# Product Change Notification

Product Group: Diodes Division / September 13, 2019 / PCN-DD-021-2019 Rev 0

## Additional Assembly Site and Mold Compound change

## TO-247AC 3L

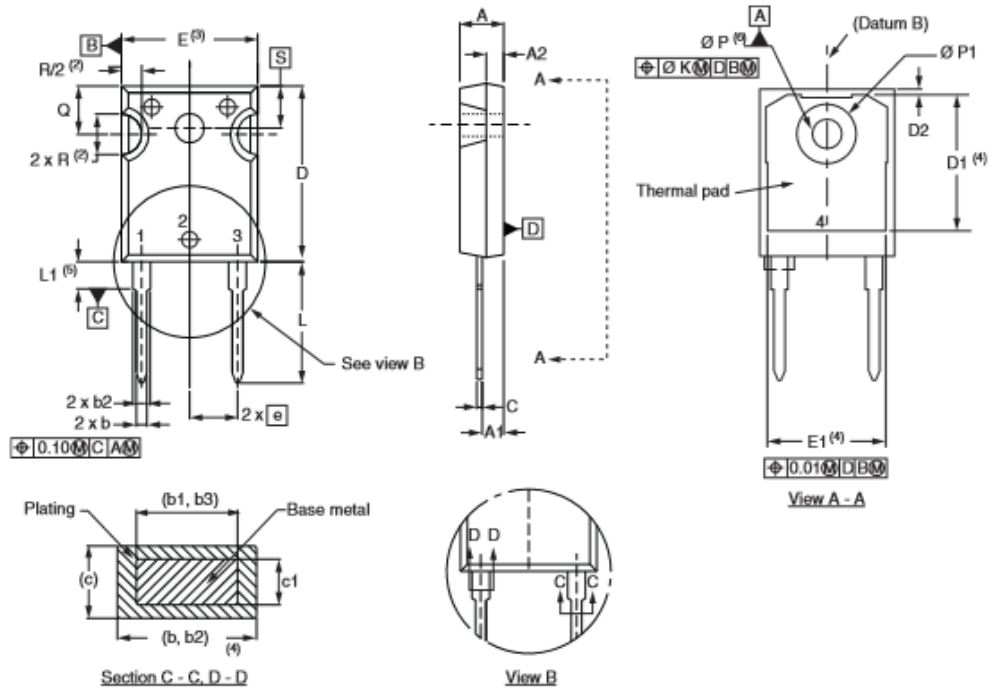
**DESCRIPTION OF CHANGE:** Vishay Semiconductors announces the introduction of an additional assembly site for below commercial TO-247 Part Numbers.  
The new subcontractor has received international quality system and environmental compliance certification ISO9001 and ISO14001.  
The mold compound will change from SG-8200DTV to EME-E-500HAC.  
The new mold compound is halogen free as the current one.  
Package Outline Dimension will be consolidated as illustrated in annex 3.
